Access Compliance Report Public Rights-of-Way (Curb Ramps)

Main Street: RAINBOW_DR Cross Street: BRITTANY_WOODS_DR Location: S

ADA ID: RPRK211014153453 Ramp Type: Type 4 - Parallel Initial Pass/Fail: Fail Overall Compliance: No Severity Score: 2

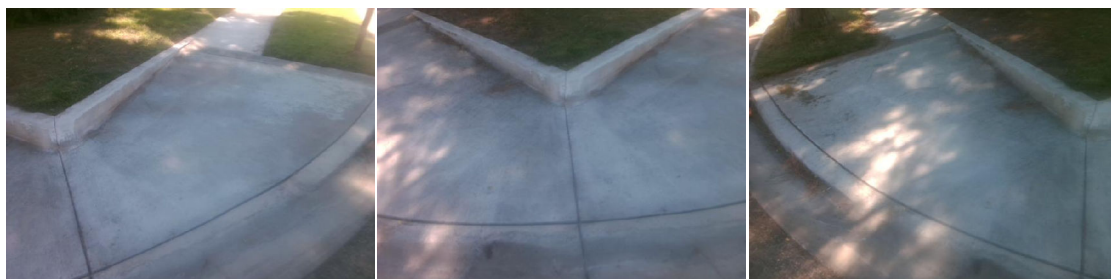
Compliance	Description	Data	Compliance	Description	Data
N/A	Ramp Length LT (in)	160	N/A	Ramp Length RT (in)	150
Yes	Ramp Width LT (in)	98	Yes	Ramp Width RT (in)	96
Yes	Ramp Run Slope LT (%)	7.9	Yes	Ramp Run Slope RT (%)	6.9
Yes	Ramp Cross Slope LT (%)	0.5	No	Ramp Cross Slope RT (%)	4.5
N/A	Landing Present	N/A	N/A	DWS Provided	N/A
N/A	Landing Length (in)	N/A	N/A	DWS Contrast	N/A
N/A	Landing Width (in)	N/A	N/A	DWS Length (in)	N/A
N/A	Landing Run Slope (%)	N/A	N/A	DWS Full Width	N/A
N/A	Landing Cross Slope (%)	N/A		DWS Offset Type	N/A
N/A	Landing Movement Obstructed?	N/A	N/A	DWS Offset Left (in)	N/A
	Landing Movement Type	N/A	N/A	DWS Offset Right (in)	N/A
N/A	Landing Shared	N/A			
N/A	Clear Space	Yes			
N/A	Clear Space To Crosswalk (in)	N/A			
N/A	Marked Crosswalk 1	No	N/A	Marked Crosswalk 2	No
	Crossing 1 Direction	NE		Crossing 2 Direction	NW
N/A	Marked Crosswalk 1 Width (in)	N/A		Marked Crosswalk 2 Width (in)	N/A

Remove & Replace Curb Ramp With Two New Directional Ramps or Equivalent.

R304.5.3, STD 1115
